**BEFORE THE PUBLIC UTILITY COMMISSION
OF OREGON
PCN-2**

INTERVENOR TESTIMONY OF DAVID MAST

January 14, 2019

David Mast – Intervenor Testimony - Issues List

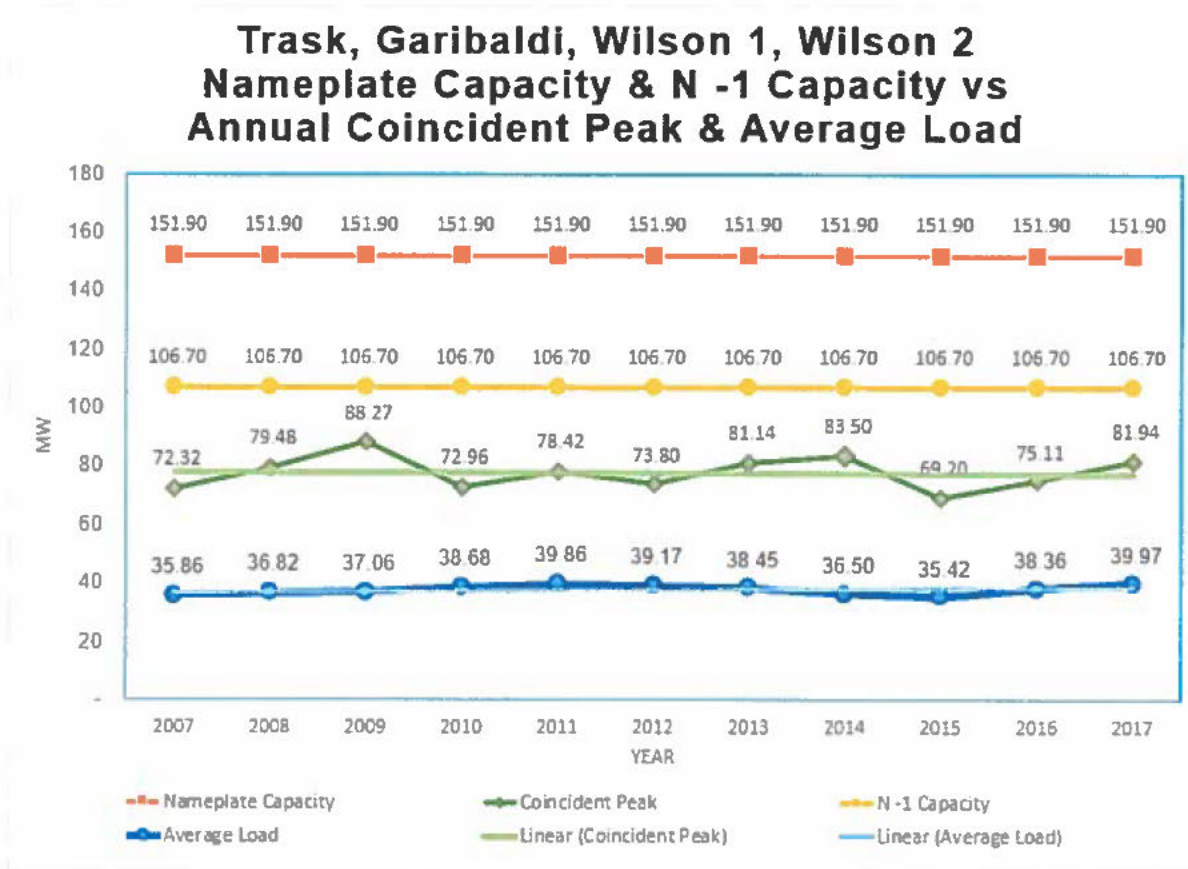
Garibaldi substation loads for every hour of every day. I summarized the data from the TPUD Exhibit and developed the chart shown below.

The total capacity of the 4 substations that feed the central valley and Oceanside – Netarts is 151.9 MW. The N -1 capacity is 106.7 MW. The maximum peak which occurred in 2009 was only 58% of the capacity of the 4 substations and only 83% of the substations’ N -1 capacity. The average load on the substations was 37.83 MW. That is only 24.9% of the substations’ total capacity and only 35.4% of their N -1 capacity.

From the data, I see that TPUD is able to adequately provide service to existing and new loads without needing to build a transmission and substation to Oceanside – Netarts.

KC Fagen's Chart – Wilson 1 & 2 Growth

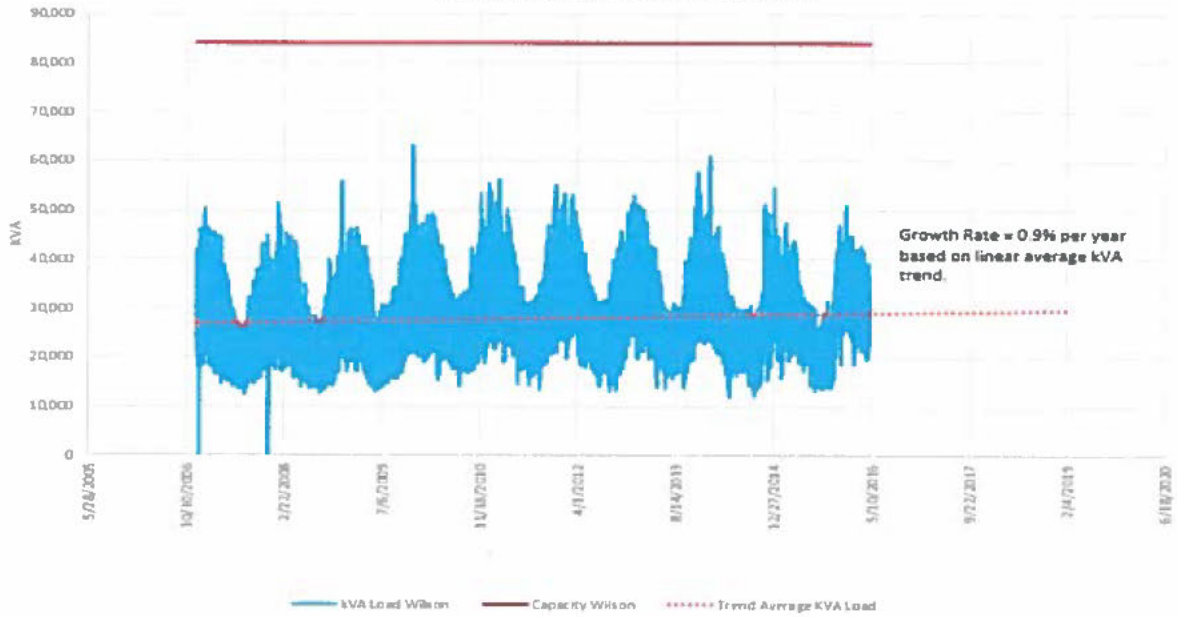
In his follow up testimony, KC Fagen reports a growth of 0.9259% per year for Wilson 1 & 2⁶. KC Fagen's 0.9259% growth for Wilson T1 & T2 is based on the load trends of the Wilson River 1 & 2 from 2006 – 2016. His analysis has the same major error and is also significantly distorted upward because it also ignores the fact that in 2009 the TCCA boiler came on line. His chart gives a false assumption about the future growth of Wilson River 1 & 2.

I took TPUD's data that KC Fagen used for his trend line and developed a trend line from 2009 – 2016 to eliminate the load distortion that occurred when the boiler came on line in 2009. The trend line for 2009 – 2016 based on TPUD's data shows that growth on Wilson River 1 & 2 was flat, showing that all the growth KC Fagen is talking about, in fact, came from the TCCA boiler going on line. (Data is from Staff DR 19 a b c e)

Wilson Substation (Serves Tillamook, Bay City, Netarts, Oceanside, Cape Meares)
Wilson Transformer 1 and 2
Historic Loading from BPA Meter Data

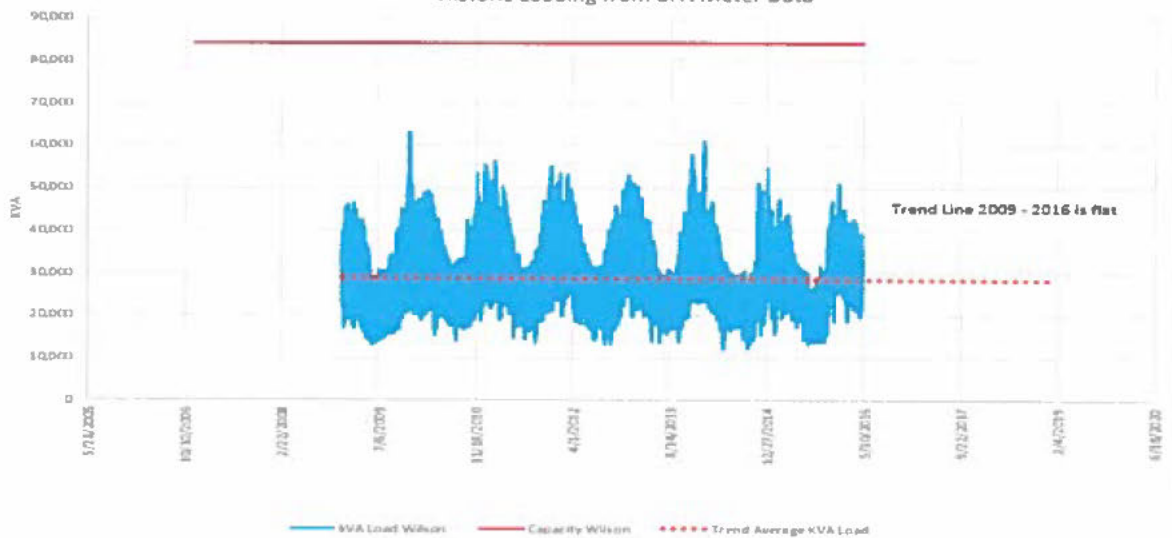
Same TPUD data as KC Fagen's just charted from 2009 - 2016

KC Fagen's 0.9259% load growth number is a significantly distorted number. The 2012 official forecast was for a total system growth of 0.45%. Actual growth from 2012 – 2017 in the total system was below 0.45%. Growth of the 4 substations that serve the central valley is only 0.20%. Wilson T1 & T2 show no growth in 2009 – 2016. The projected growth in the 2019 Budget is only 0.5%⁷. Nowhere do any of the growth numbers come close to the 0.9259% he is using to justify the need for the transmission line and substation.

Wilson 1, Wilson 2 Nameplate Capacity vs Annual Coincident Peak and Average Load 2010 - 2017

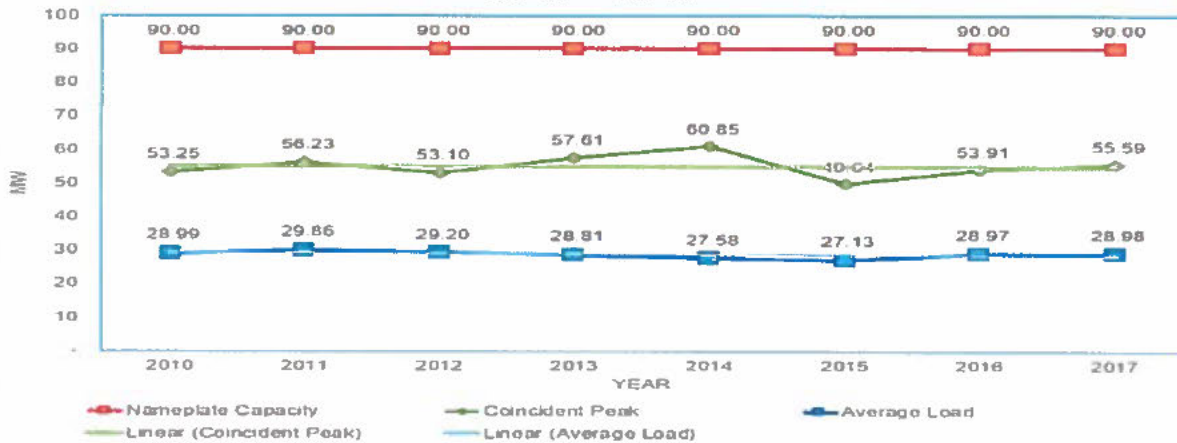
Below, I have graphed the average loads and coincident peaks for Wilson 1 & 2 starting in 2010 after the 4 MW TCCA electric boiler went on line. You can see that the coincident peaks and average loads of the Wilson 1 & 2 after 2009 are flat.

Trask Substation Nameplate Capacity vs Annual Coincident Peak & Average Load

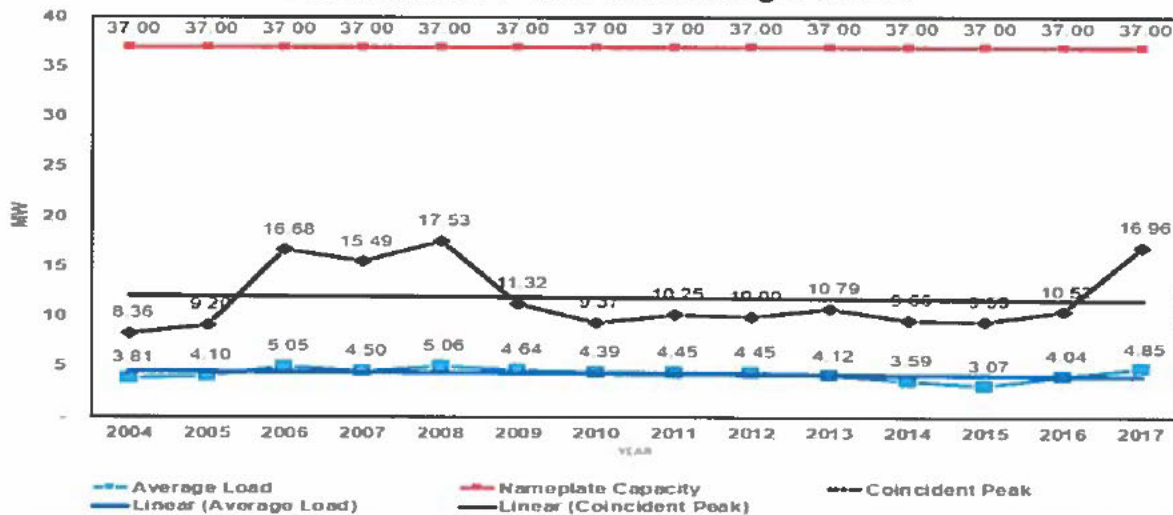
The Trask substation is only loaded at 12% of capacity and the highest coincident peak was only 47% of capacity. Moving feeder 51 to the Trask would relieve 5 – 12 MW from the Wilson River T1 & T2 and it would put the Task at a more efficient level. The \$16 transmission line/substation is planned to take load off the Wilson Rivers. Moving feeder 51 to the Trask accomplishes the same thing for a lot less cost.
